Access Compliance Report

Public Rights-of-Way

(Curb Ramps)

Intersection ID: 13911	Main Street: LEXINGTON_AV	Cross Street: ORIOLE_AV	Location:	N
ADA ID: EAF168FE1C50	Ramp Type: Perp	Initial Pass/Fail: Fail	Overall Compliance: No	Severity Score: 13.75
Codes/Mitigation Info/Possible Solution		Field Measurements/Component Compliance

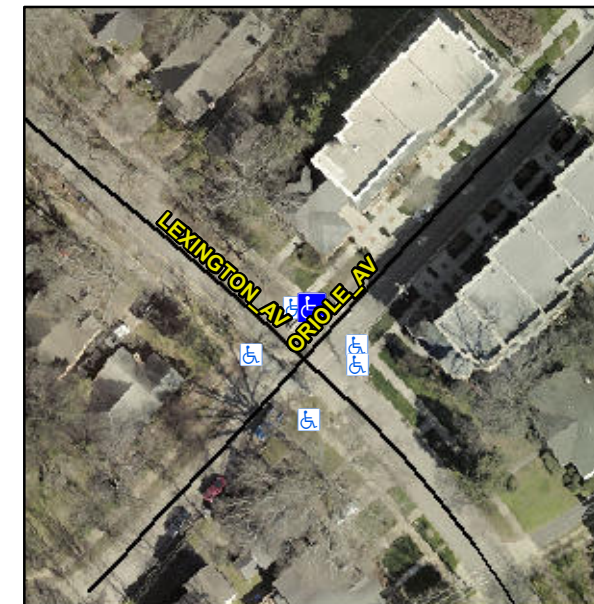
Not Found, R304.2.2, R304.5.3

Compliance	Description	Data	Compliance	Description	Data
N/A	Ramp Length (in)	78.0	No	Ramp Slope (%)	8.7
Yes	Ramp Width (in)	48.0	No	Ramp XSlope (%)	2.4
N/A	Flare Type LT	N/A	N/A	Flare Type RT	N/A
N/A	Flare Slope LT (%)	N/A	N/A	Flare Slope RT (%)	N/A
N/A	Flare Traversable LT?	N/A	N/A	Flare Traversable RT?	N/A
N/A	Landing Length (in)	N/A	N/A	DWS Provided?	N/A
N/A	Landing Width (in)	N/A	N/A	DWS Contrast?	N/A
N/A	Landing Slope (%)	N/A	N/A	DWS Length (in)	N/A
N/A	Landing X Slope (%)	N/A	N/A	DWS Full Width?	N/A
N/A	Landing Curb? (Y/N)	N/A	N/A	DWS Offset (in)	N/A
N/A	Shared Landing?	N/A			
N/A	Gutter Ponding?	N/A	N/A	Gutter Slope (%)	N/A
N/A	Gutter Lip Ht (in)	N/A	N/A	Gutter X Slope (%)	N/A
N/A	Painted X Walk1?	No	N/A	Painted X Walk2?	N/A
	X Walk 1 Direction	To SE		X Walk 2 Direction	N/A
N/A	X Walk 1 Width (in)	N/A	N/A	X Walk 2 Width (in)	N/A
	X Walk 1 Slope (%)	0.7		X Walk 2 Slope (%)	N/A
	X Walk 1 X Slope (%)	1.0		X Walk 2 X Slope (%)	N/A

Remove & Replace Entire Ramp.
